EL PASO COUNTY, COLORADO

FRONT RANGE-MIDWAY (FRMW) WIND/SOLAR ENERGY OVERLAY (WSE-O) PLAN

WIND/SOLAR ENERGY GENERATION OVERLAY (WSE-O) PLAN (WSEO-17-001) FOR THE FRONT RANGE-MIDWAY SOLAR PROJECT EL PASO COUNTY, COLORADO **EXISTING STRUCTURES** WSEO-17-001 DISTRICT BOUNDARY And the state of t FEMA FLOOD ZONE A PROPOSED WSE-O FENCE _x _ x _ OPERATIONS AND INTERCONNECTION SUBSTATION ARRAY BOUNDARY MANAGEMENT - SOLAR MODULES ON TRACKERS TYPICAL, PROPOSED 115kV CIRCUIT SEE SHEET 12 & 13 FOR DETAILS THE PROJECT SUBSTATION WILL + NON-JURISDICTIONAL WATER FEATURES STEP UP THE POWER TRANSPORTED EXISTING 115kV CIRCUIT TO BE AVOIDED VIA THE UNDERGROUND COLLECTION LINES TO 115 KV DEPENDING ON THE FINAL POINT OF INTERCONNECTION PROPOSED 230kV CIRCUIT EXISTING 230kV CIRCUIT PRIVATE ROAD TO REMAIN OPEN PROPOSED ELECTRICAL COLLECTION EXISTING ROAD CENTERLINE SEE SHEET 13 FOR DETAILS — — FEMA FLOOD BOUNDARY EXISTING 115kV -TRANSMISSION LINES DC TO AC INVERTERS TYPICAL OF 33 SEE SHEETS 15 & 16 FOR DETAILS EXISTING R.O.W. (NO ROAD) WATER FEATURE TO 100 BE AVOIDED / DRAINAGE BASIN/POND (TYPICAL) RÁNCHO COLORADO BLVD. METEOROLOGICAL STATION TYPICAL OF 5 SEE SHEET 14 FOR DETAIL THE DISTANCE BETWEEN TH

VICINITY MAP

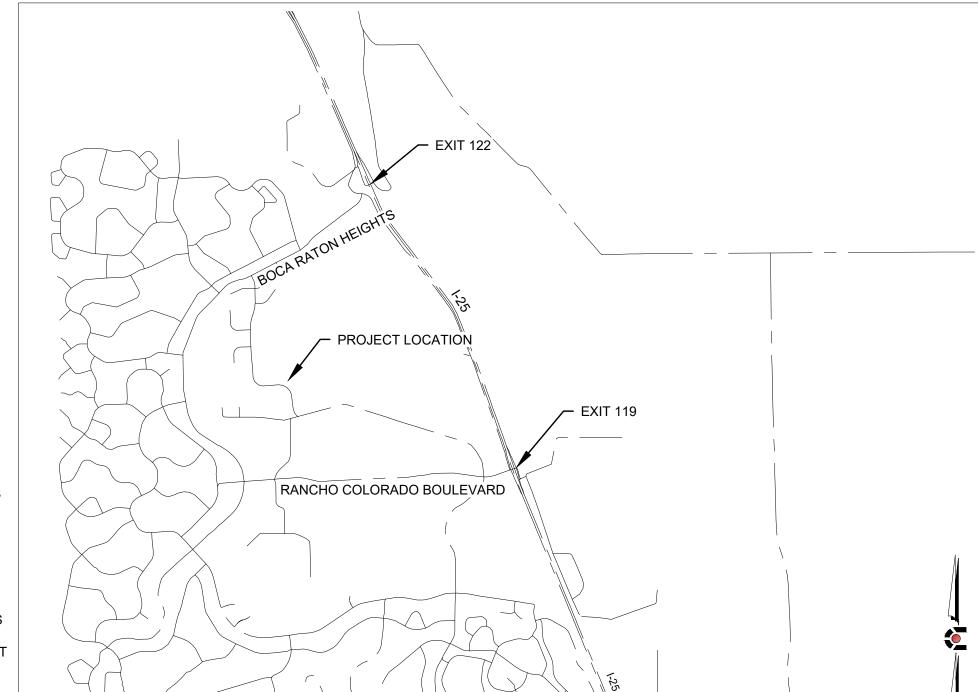
coorect to match the

recordingnext week

this is for this WSEO

17-1, this will remove

these parcels or you

will need to add the

energy from those

energy amount...

parcels to your total

201 not the WSEO

VR it should be

> is this including the existing parcels that

delete this is for

approval

are to no longer have the WSEO overlay? GENERATING CAPACITY: or are you proposing to add additonal overlay area and continue to keep the Fountain Valley PArcels? VEry confusing here and in the LOI.

WE NEED TO
AMEND THE 2017
WSEO TO REMOVE
THE PREVIOUS
LOCATIOSN SO
THAT POWER IS
NOT INLCUDED

LEGAL DESCRIPTION

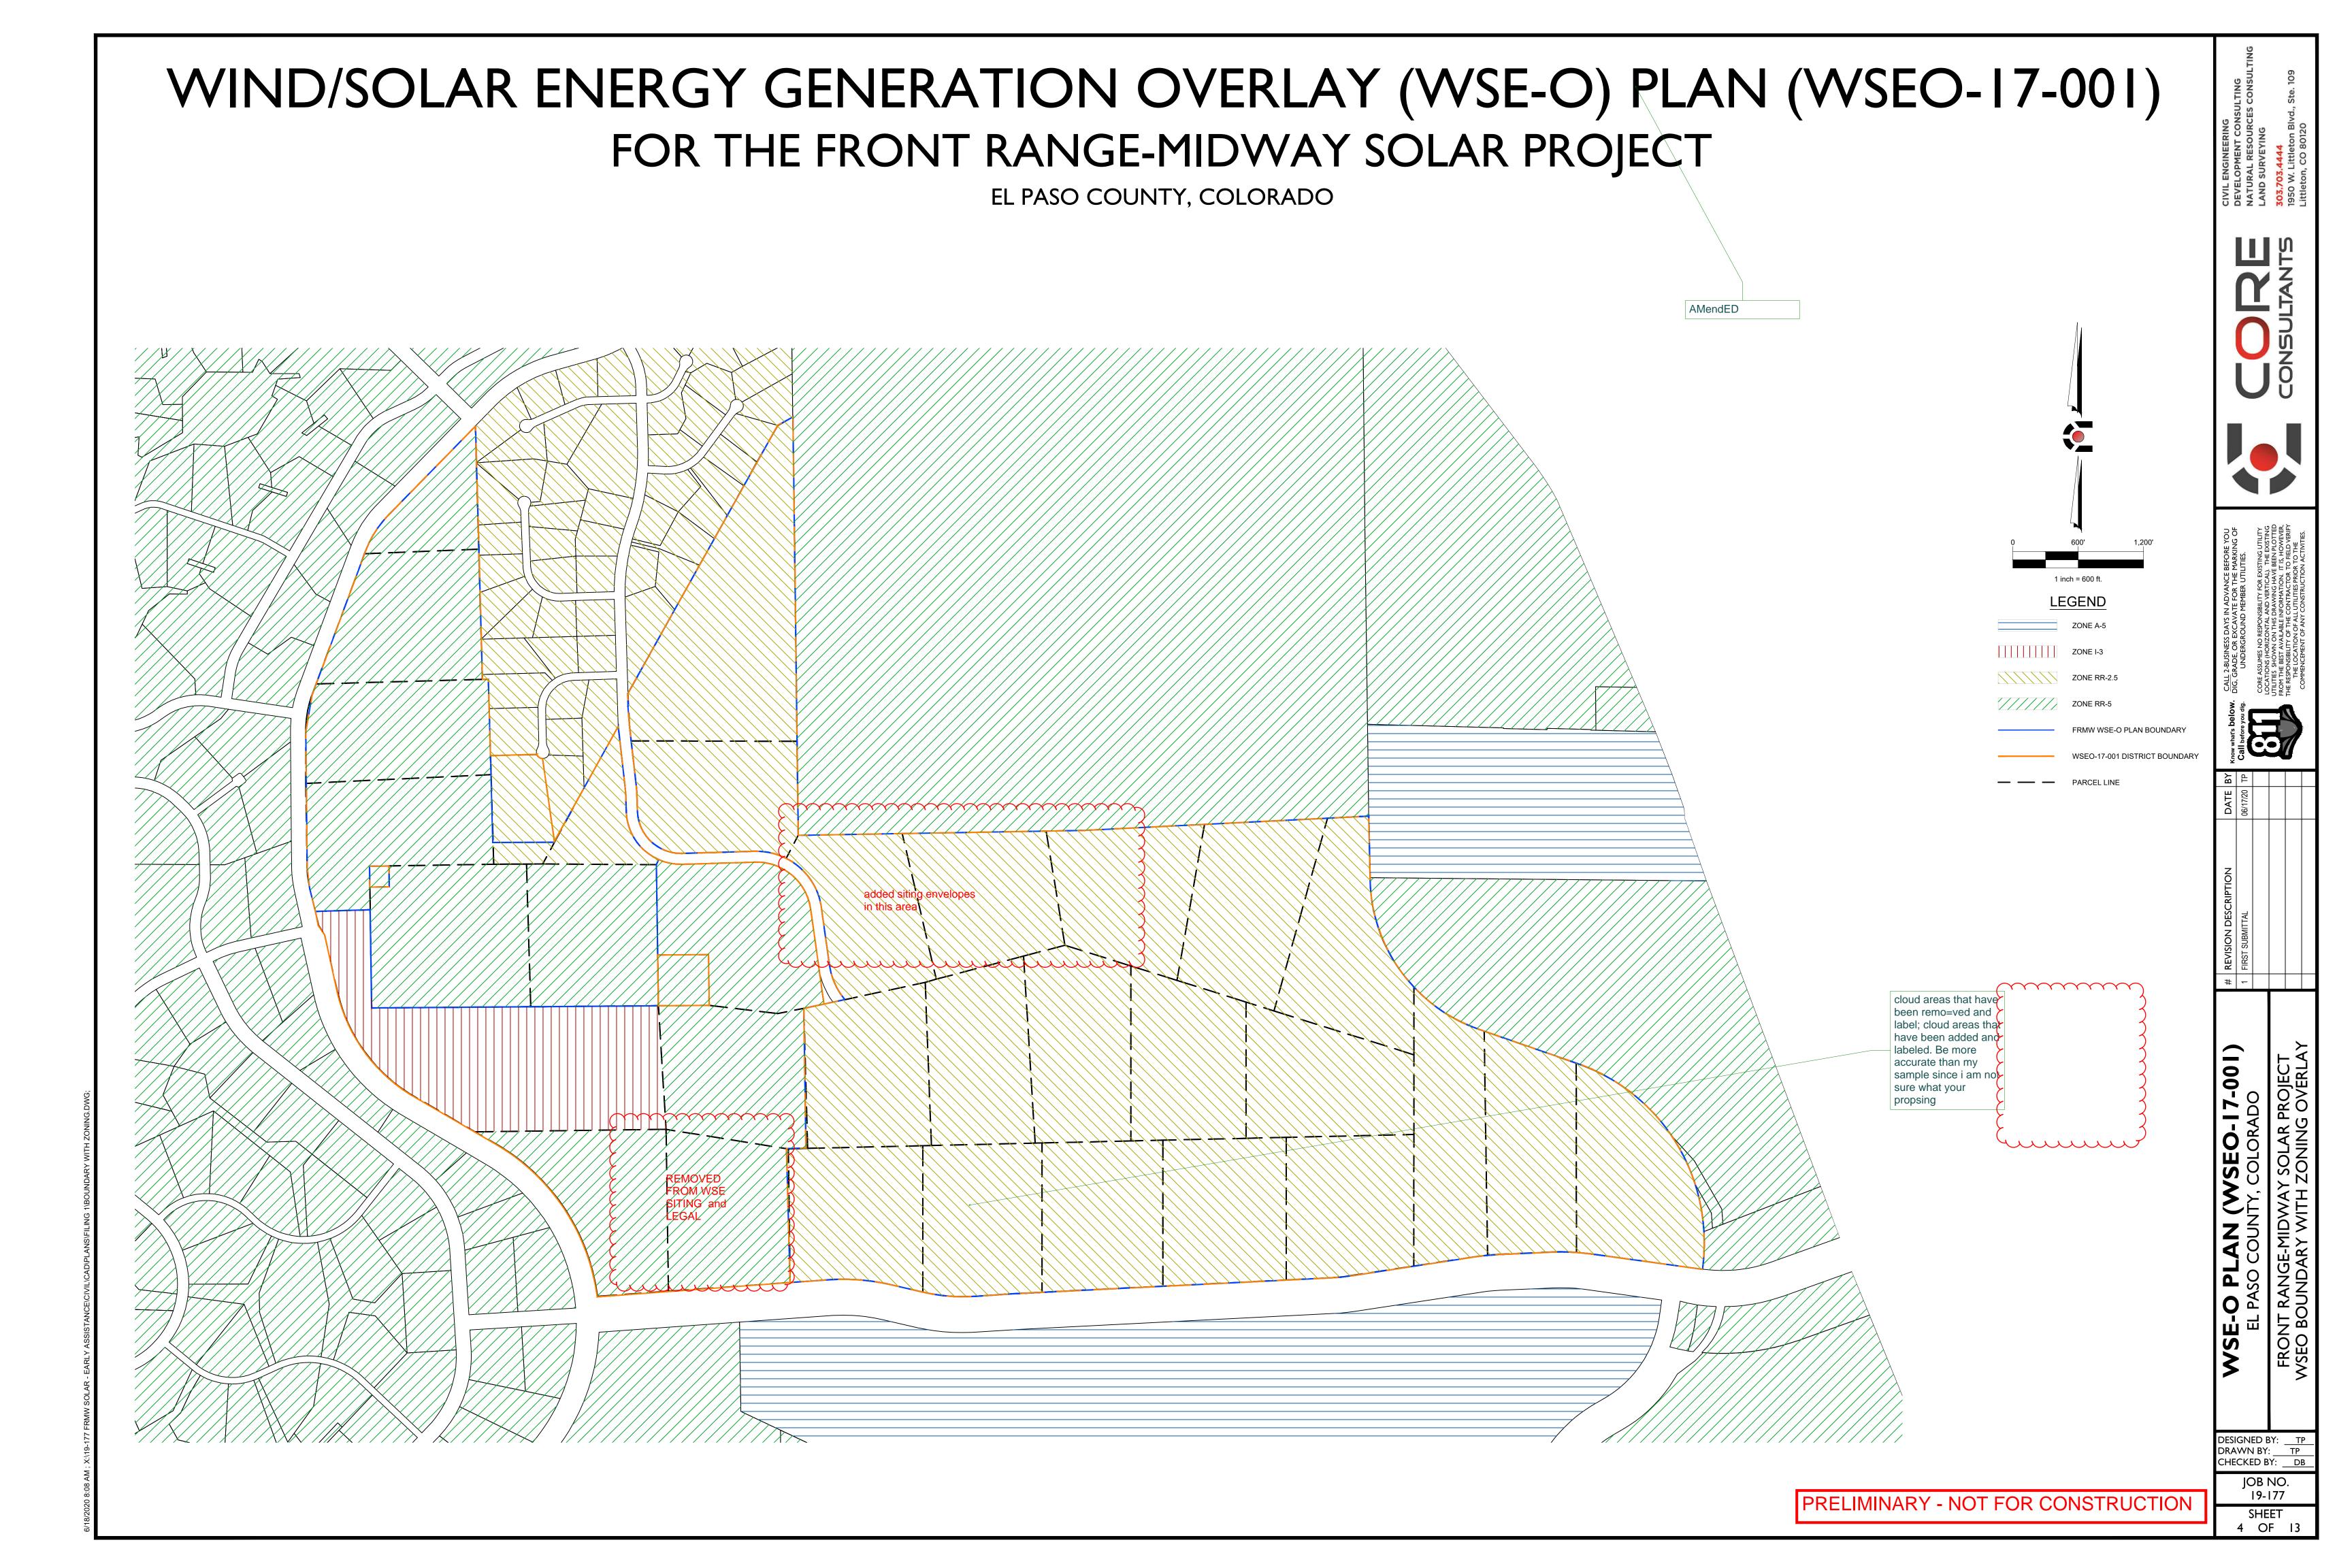
legal description total to be completed by a surveyor; this will change after the

recording of the VR

5 OF 13

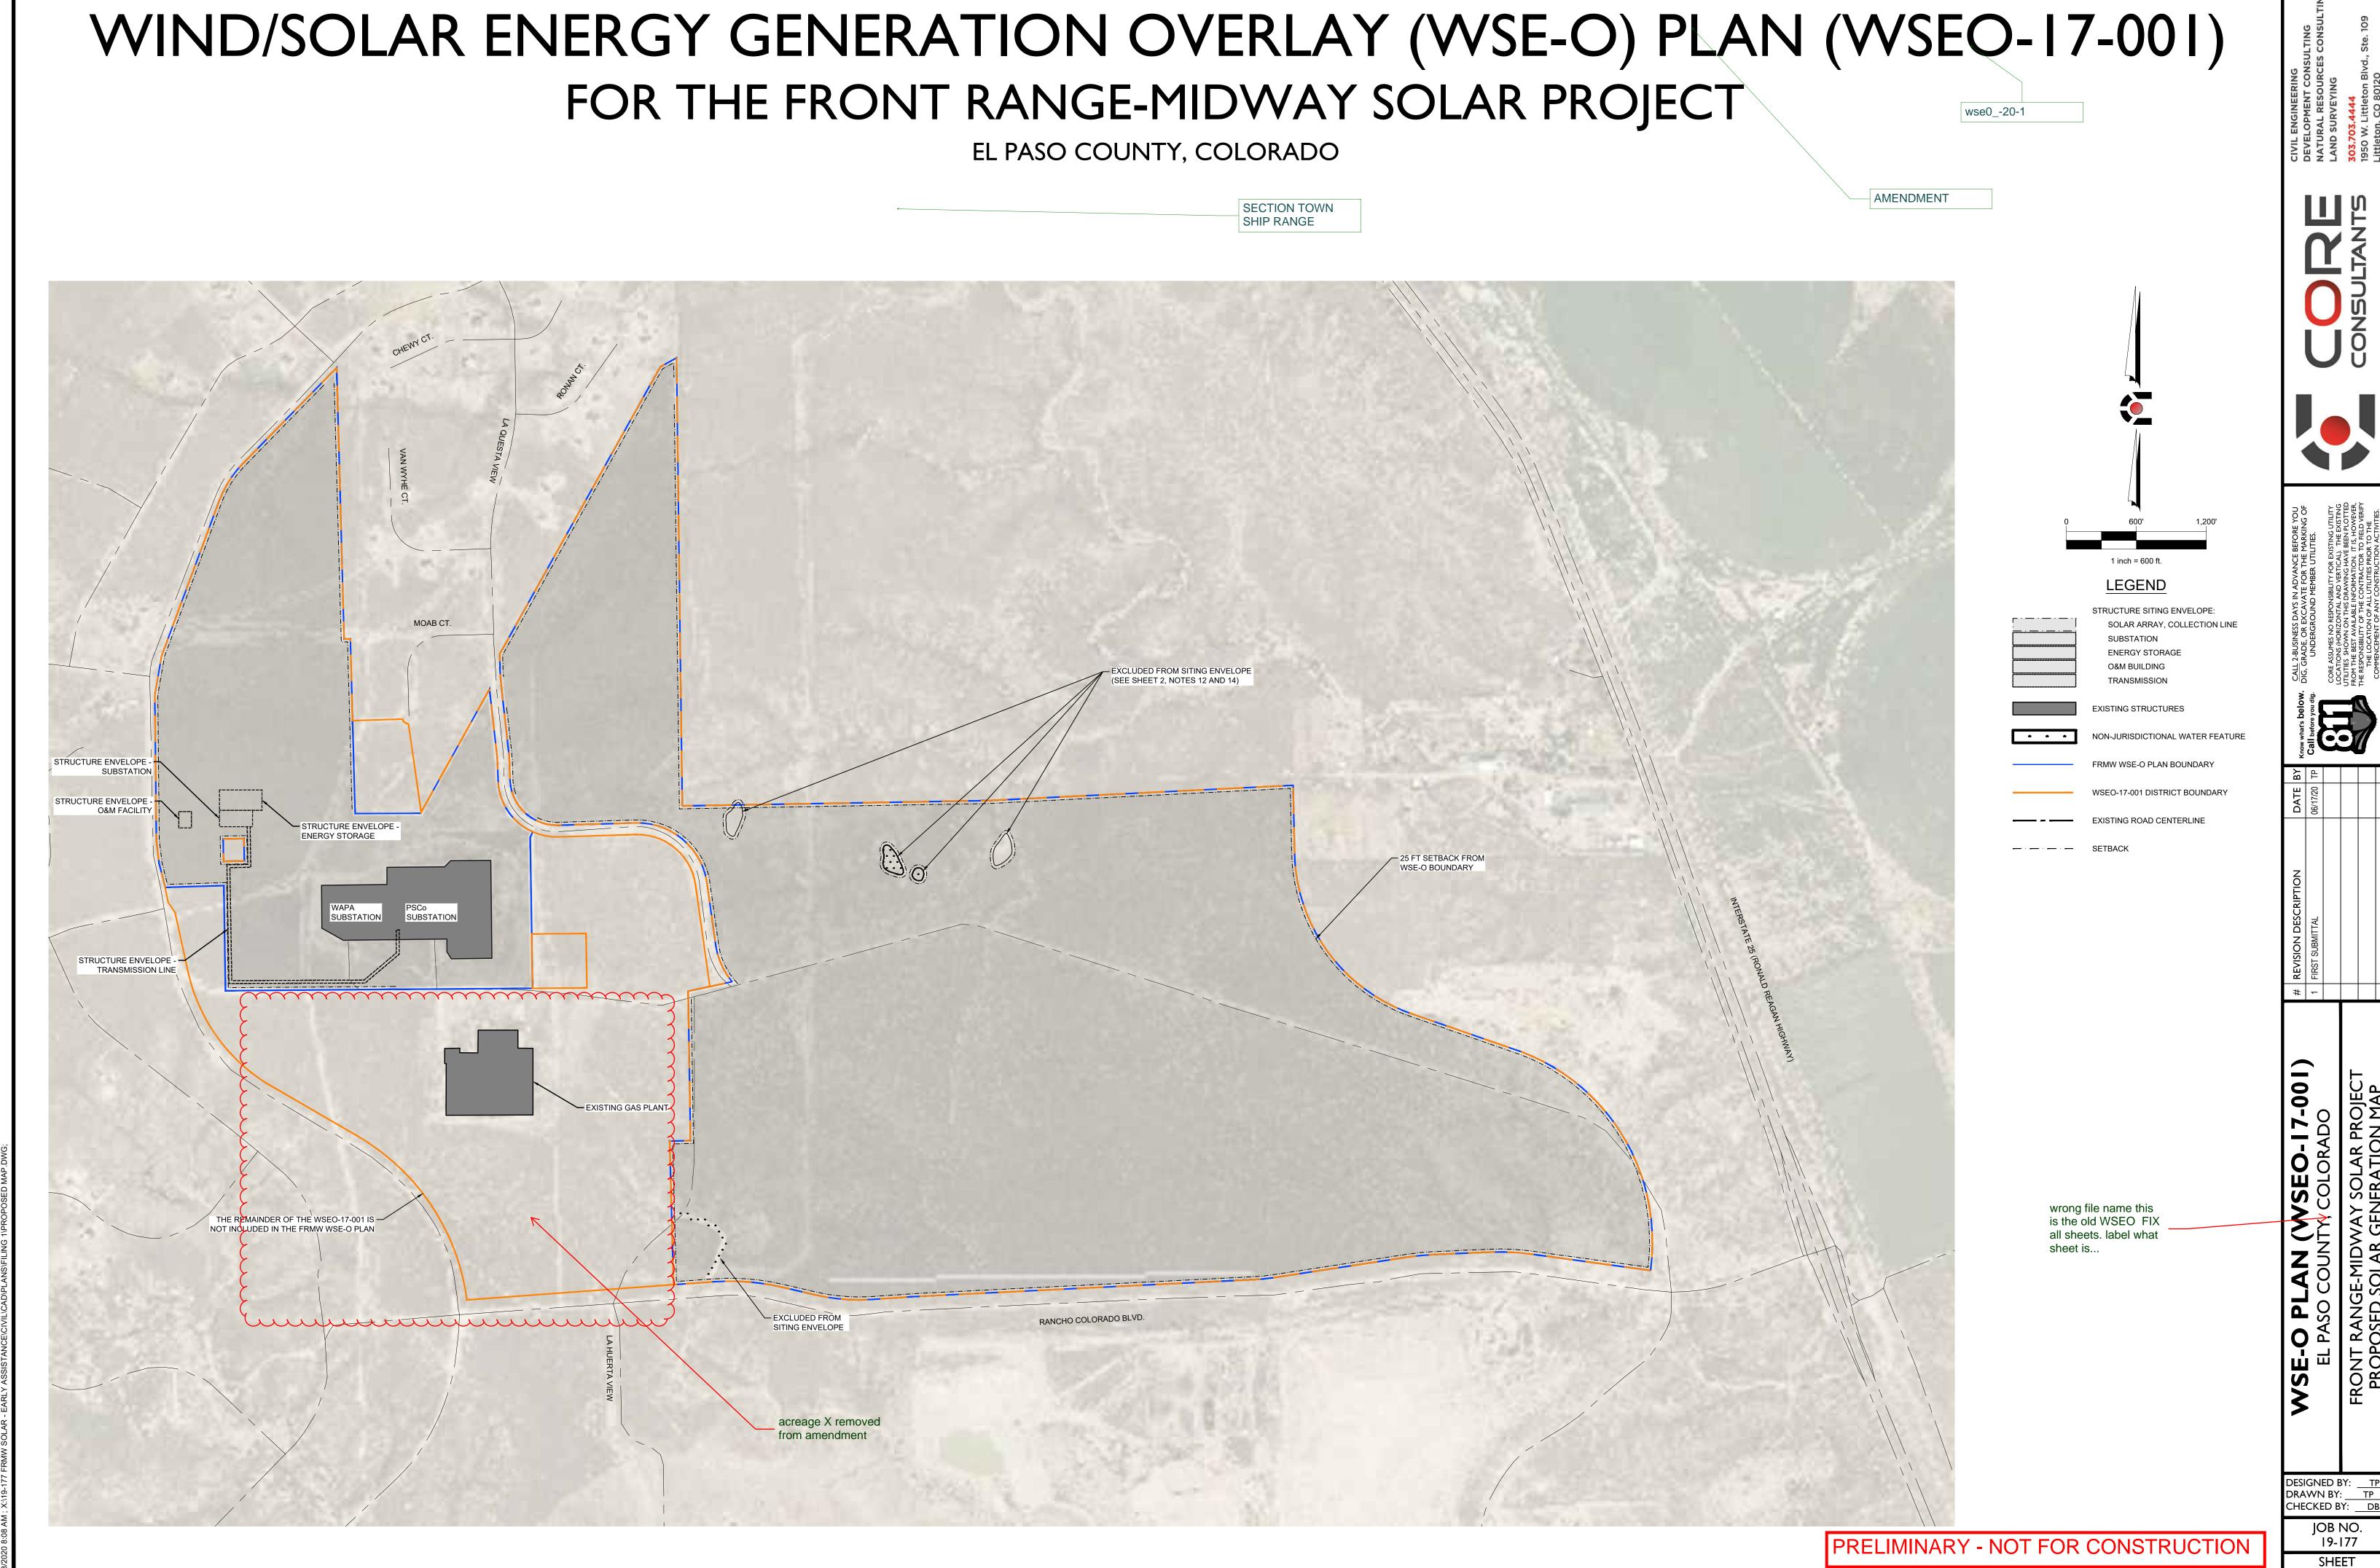
wrong file name this is the old WSEO FIX all sheets. label what sheet is...

AMENDMENT

wse0_-20-1
